Specifying PLCA delay and overflow behavior

Specifying PLCA delay and overflow behavior

Presenter: Wojciech Koczwaro, Rockwell Automation

PLCA variable delay line

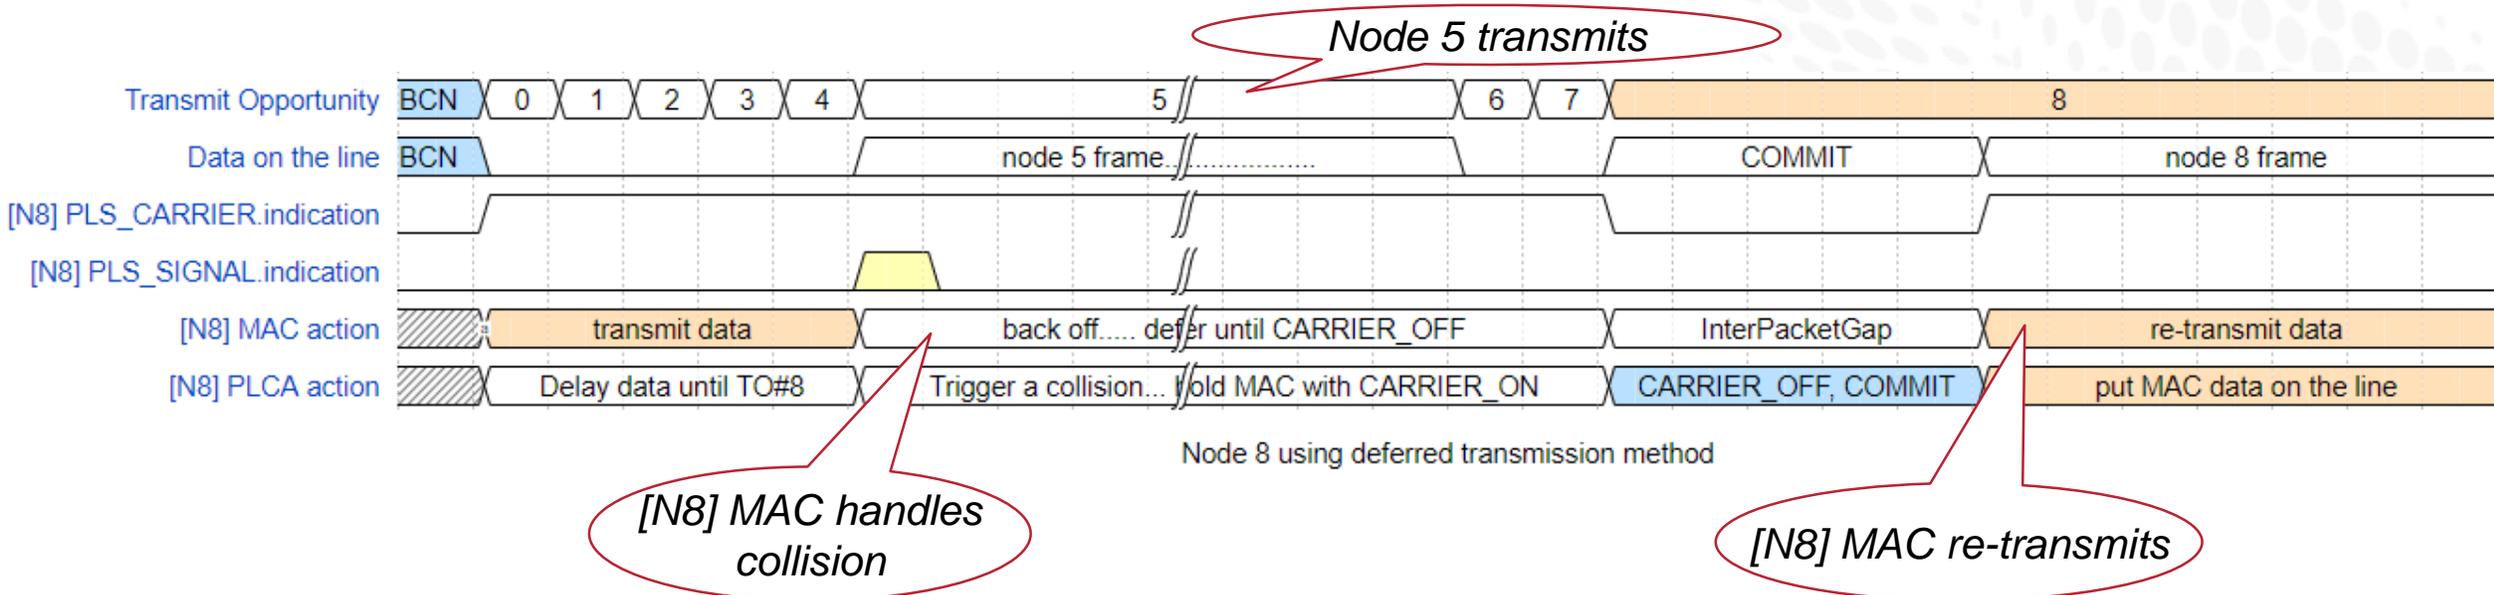
IF $to_timer \times plca_node_count + beacon_timer > slotTime$

THEN the maximum delay line length can exceed the late collision threshold in MAC.

PLCA with big delay line (large number of nodes) - **PROBLEM**

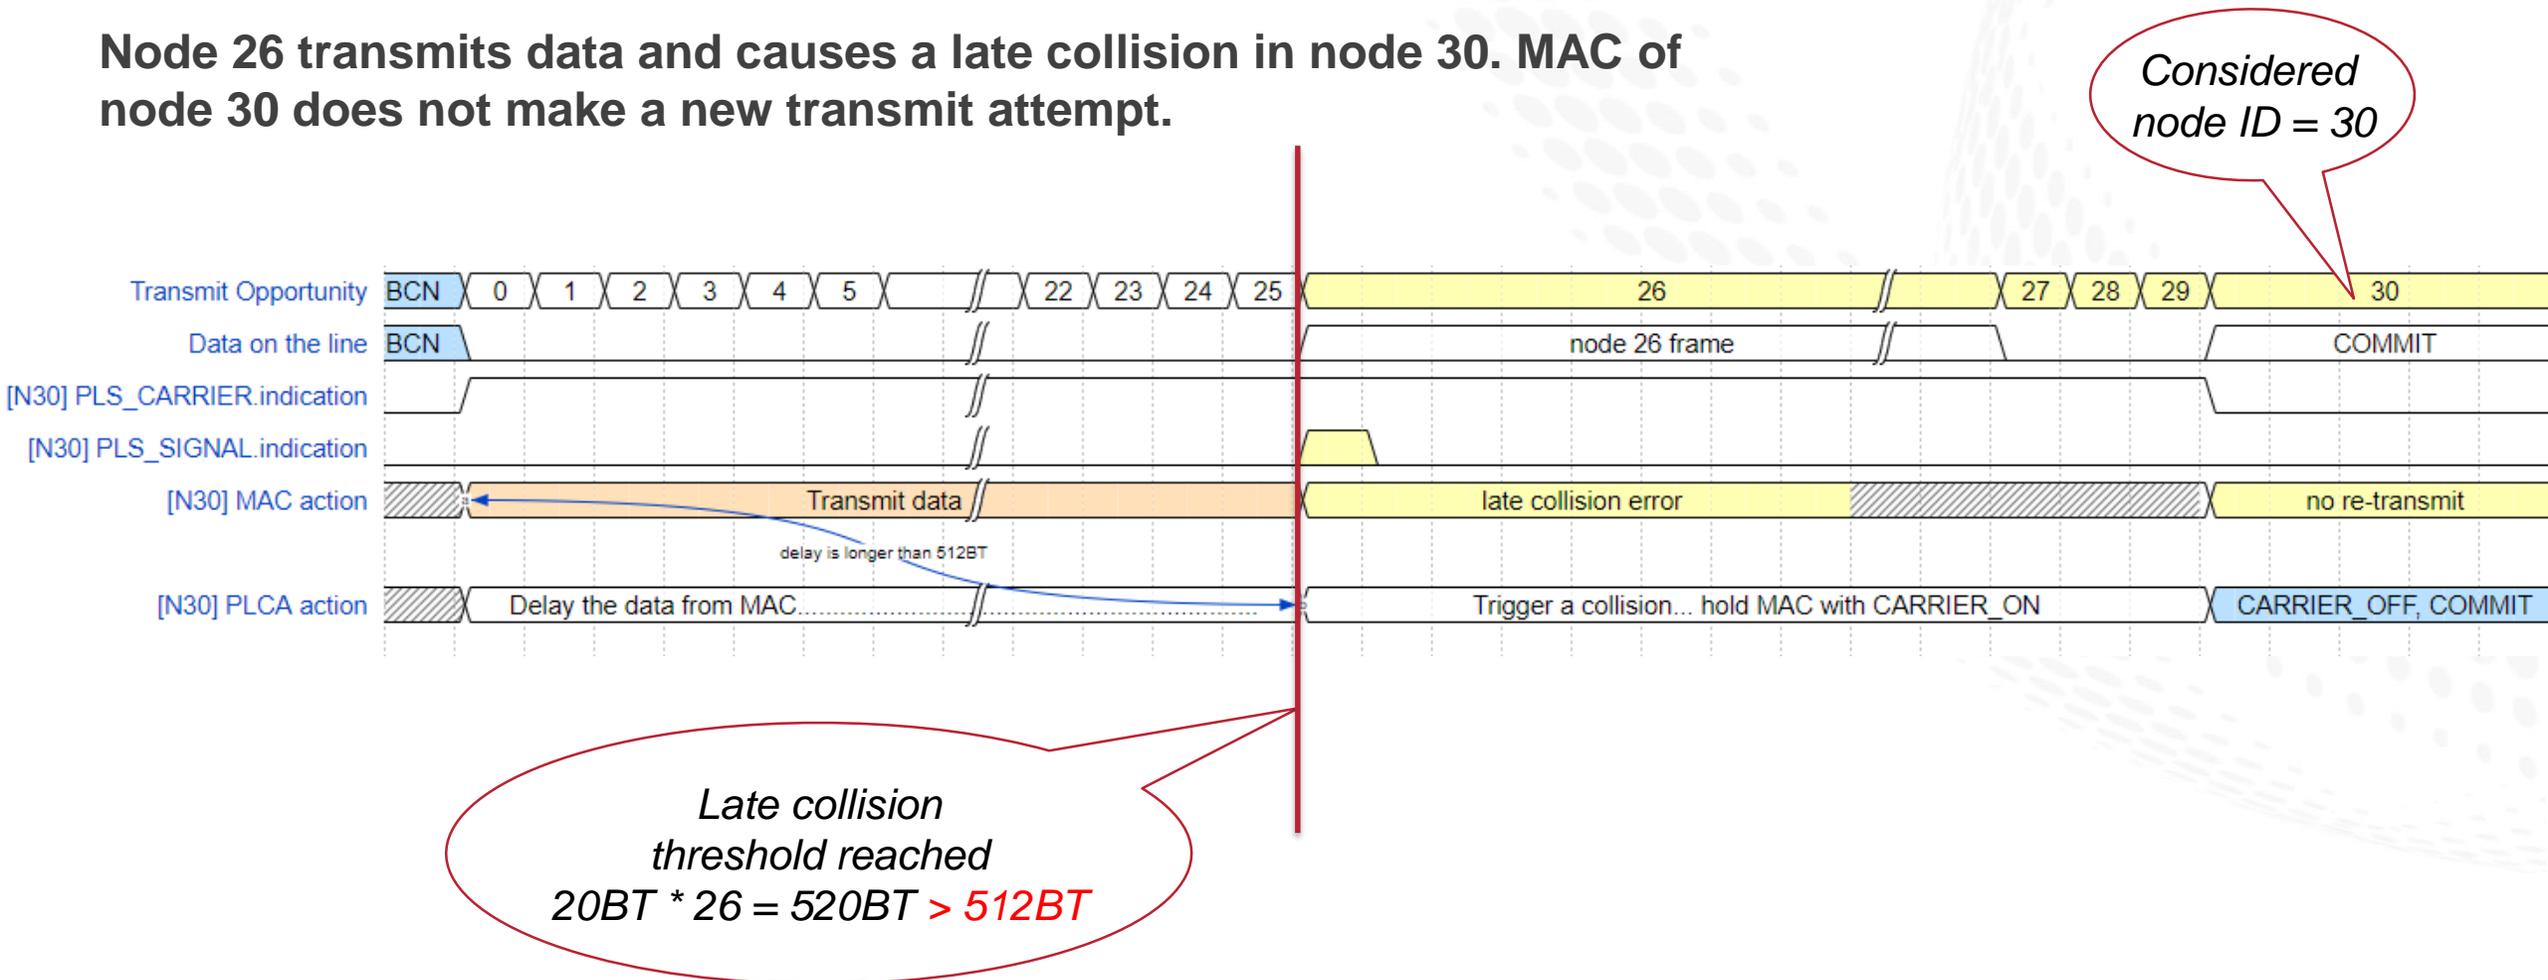
Due to excessive delay, late collision threshold ($\geq 512\text{BT}$) is reached in MAC.

Node 26 transmits data and causes a late collision in node 30. MAC of node 30 does not make a new transmit attempt.

PLCA with big delay line (to_timer = 60BT) – PROBLEM

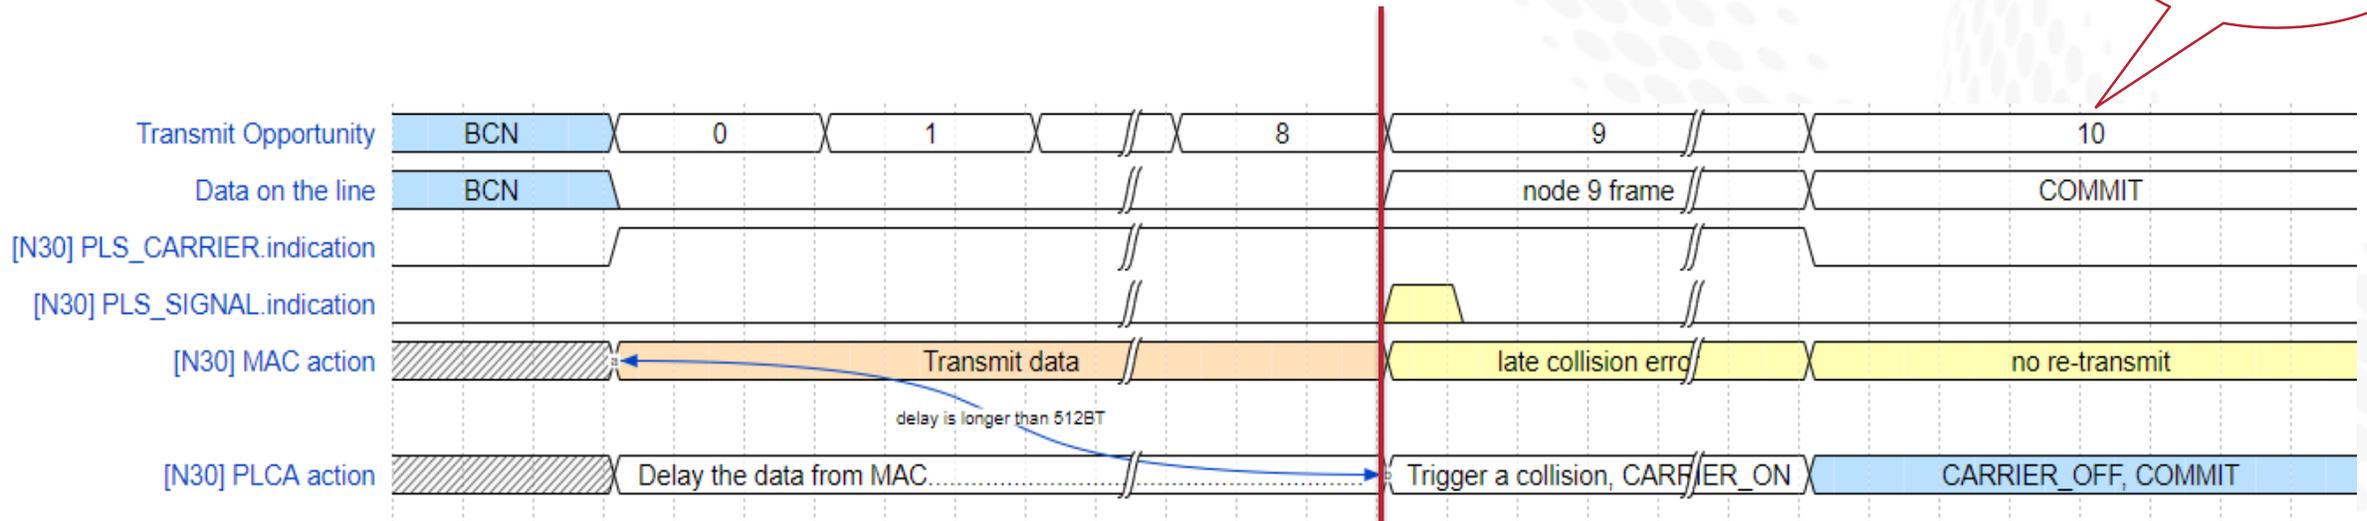
Due to excessive delay, late collision threshold ($\geq 512\text{BT}$) is reached in MAC.

Node 9 transmits data and causes a late collision in node 10. MAC of node 10 does not make a new transmit attempt.

Late collision threshold reached
 $60\text{BT} * 9 = 540\text{BT} > 512\text{BT}$

Figure 148-4—PLCA DATA state diagram

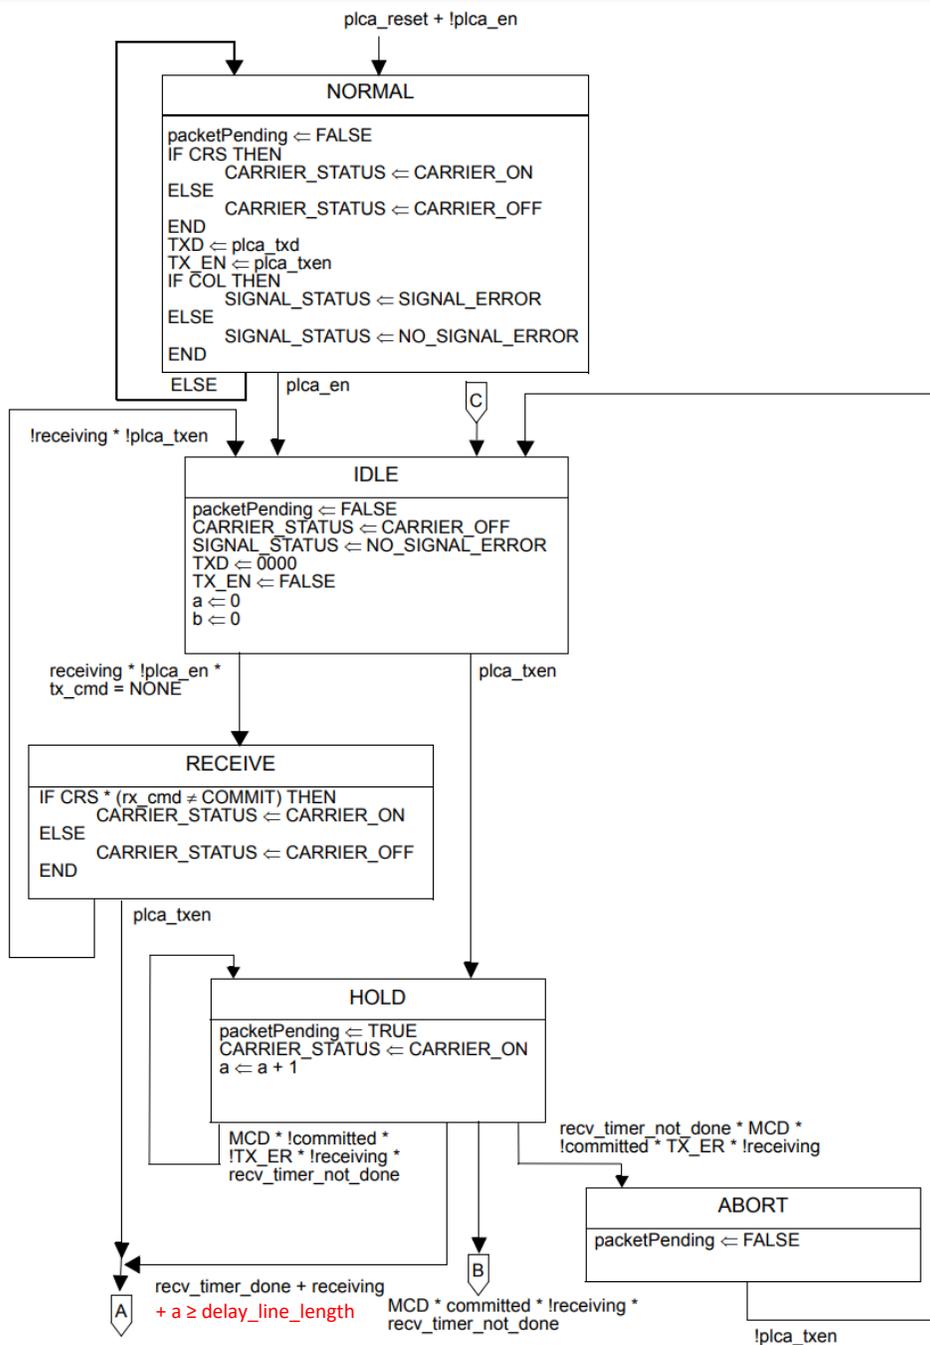
In Figure 148-4, in the transition from the HOLD state to the A connector, change the condition to:

“
 rcv_timer_done +
 receiving +
 a ≥ delay_line_length
 “

Figure 148-4—PLCA DATA state diagram (continued)

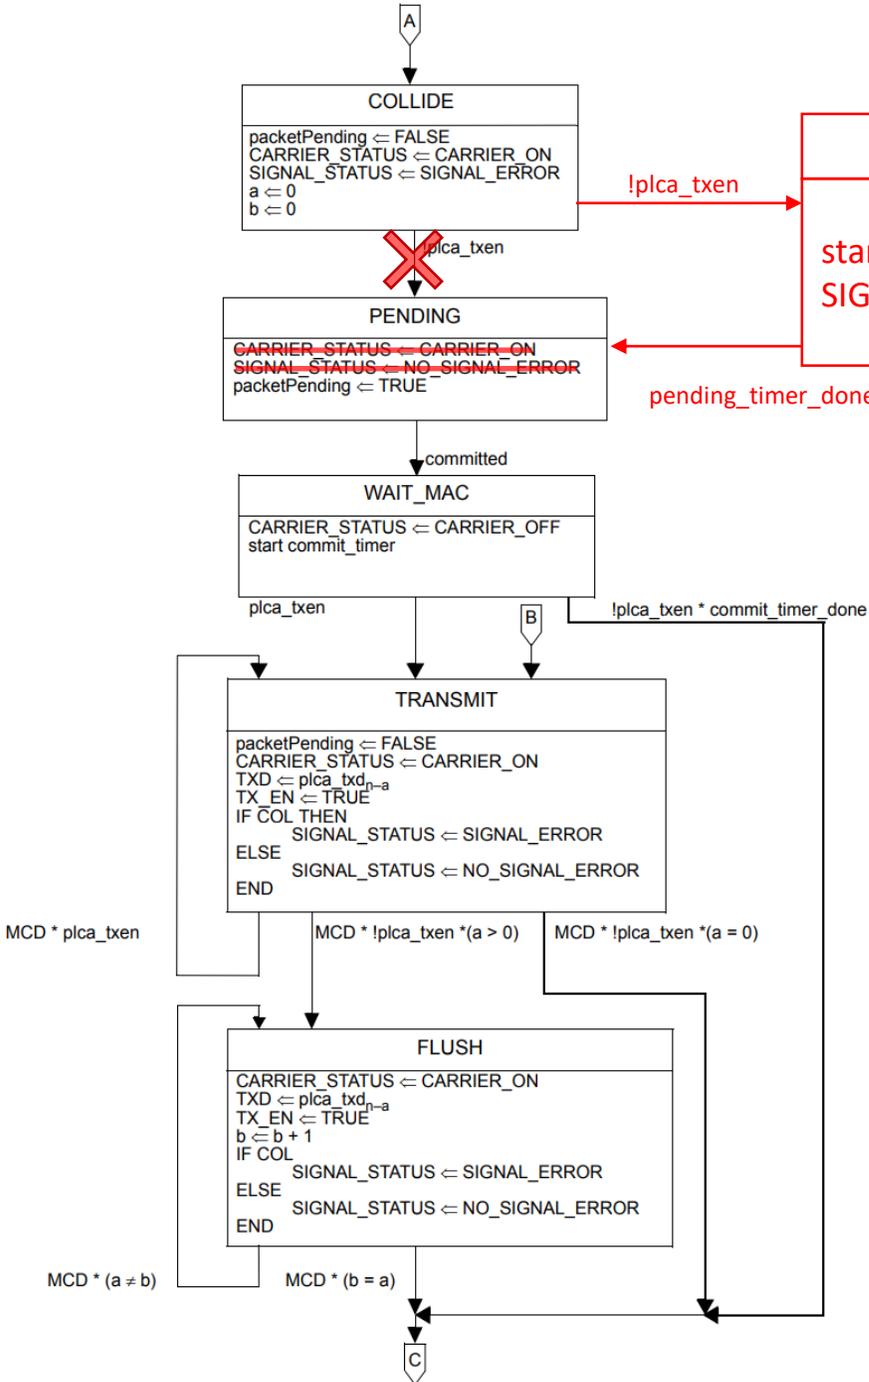
In Figure 148-4 do the following:

1. remove the transition from the COLLIDE to the PENDING STATE and its associated condition
2. In Figure 148-4, add a new state DELAY_PENDING between COLLIDE and PENDING states.
3. Add a transition between COLLIDE and DELAY_PENDING states with the following condition: “!plca_txen”
4. Add a transition between DELAY_PENDING and PENDING states with the following condition: “pending_timer_done”
5. Add the following text inside the DELAY_PENDING state box: “start pending_timer
SIGNAL_STATUS <= NO_SIGNAL_ERROR”
6. From the PENDING state delete “CARRIER_STATUS <= CARRIER_ON” and “SIGNAL_STATUS <= NO_SIGNAL_ERROR”
